<b>DESCRIPTION:</b>  Quarry Lake Redevelopment	<b>ADDENDUM NUMBER: ONE</b>
	<b>DATE OF ISSUE: August 22, 2023</b>
	<b>ISSUED BY: Amy Bernard</b>
	<b>PAGE(S): 9</b>

QUARRY LAKE PARK JUMPING PLATFORM

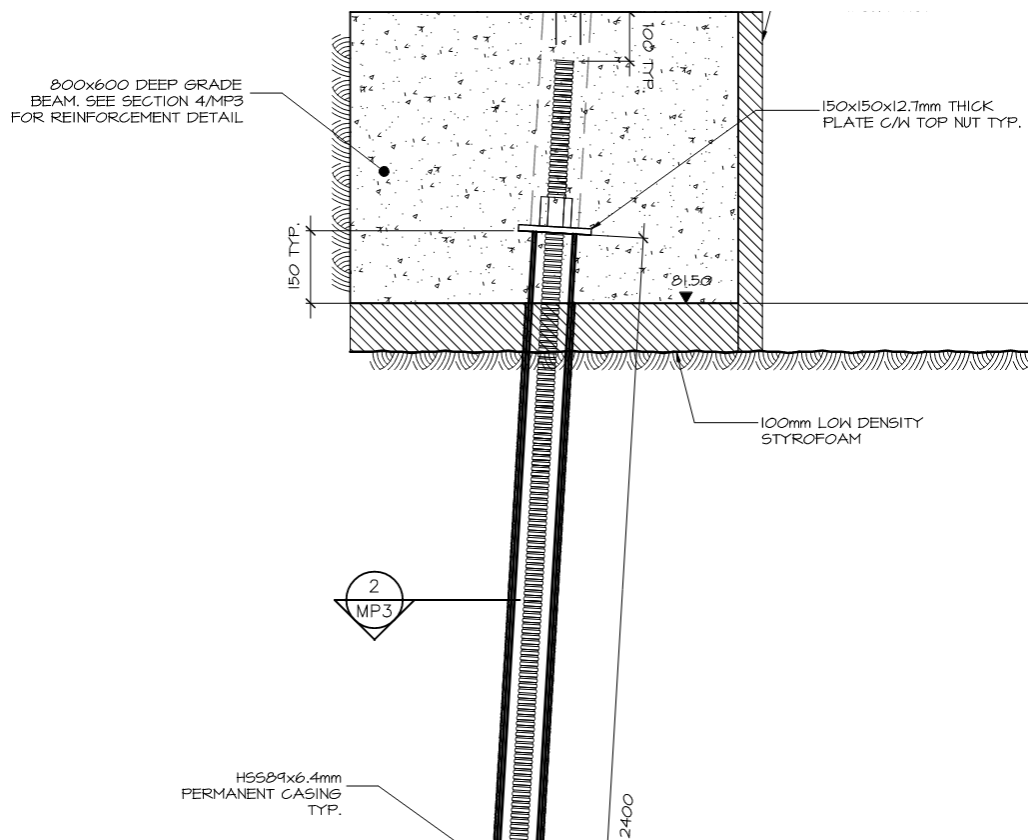
Question: What is the connection detail between the micropiles and the concrete beam?

Response: Micropile connections to concrete to be detailed in micropile shop drawings, typically embedded in concrete. See below for example of embedded connection detail from a previous project.

5 CONCRETE BEAM DETAIL  
S03 1:15

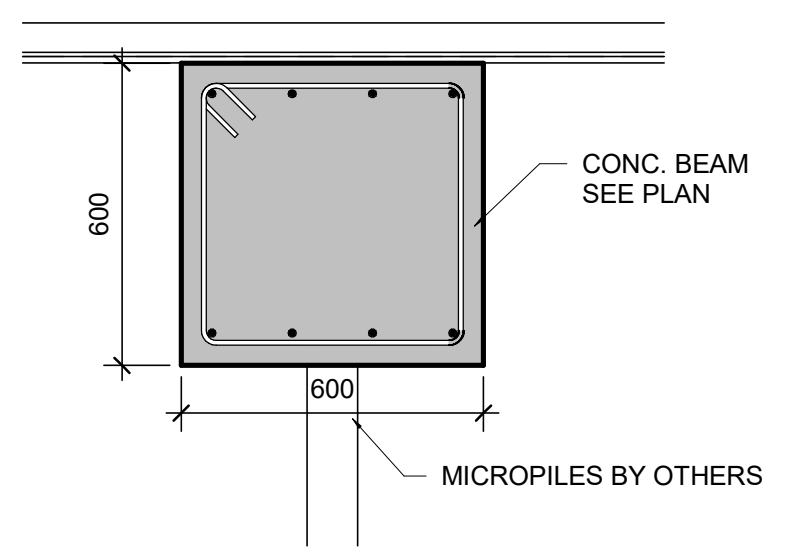
Question: On Section 5/S03 the note states "Micropiles by others". Is this correct?

Response: "By Others" indicates design by piling contractor, not by ISL. Stamped pile shop drawings to be submitted for structural and geotechnical review.

1 QUARRY LAKE PARK JUMPING PLATFORM PLAN  
S03 1:50

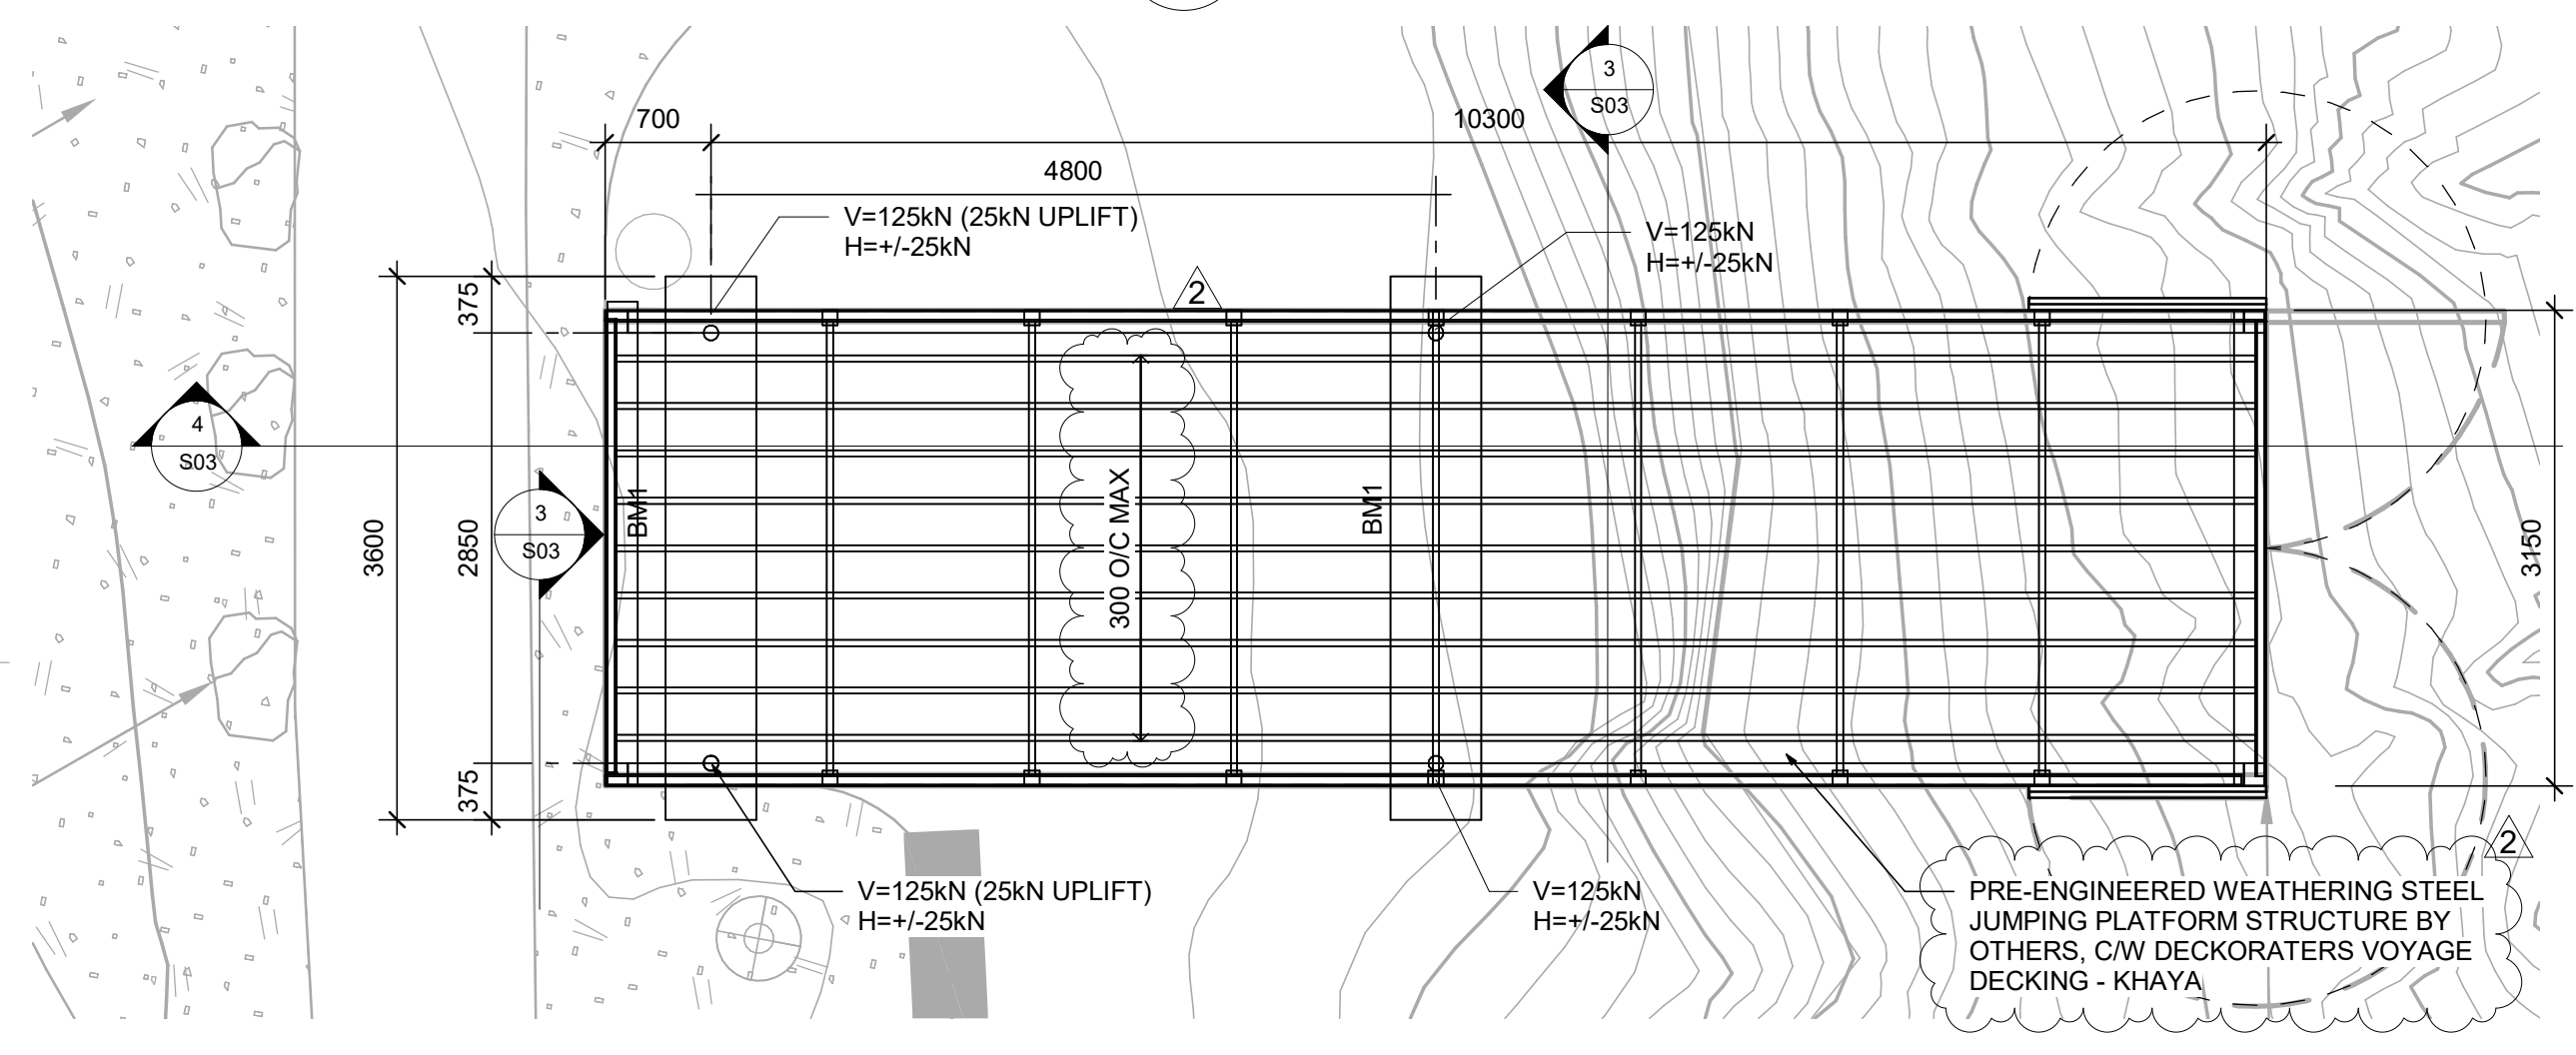
Question: The tender summary states "Supply and install of a prefabricated steel structure jumping platform", however on Detail Plan 1/S03 the note states "Pre-engineered Jumping Platform Structure by others". Which is correct?

Response: Weathering steel cantilever structure to be pre-engineered/fabricated by supplier to the design loads.
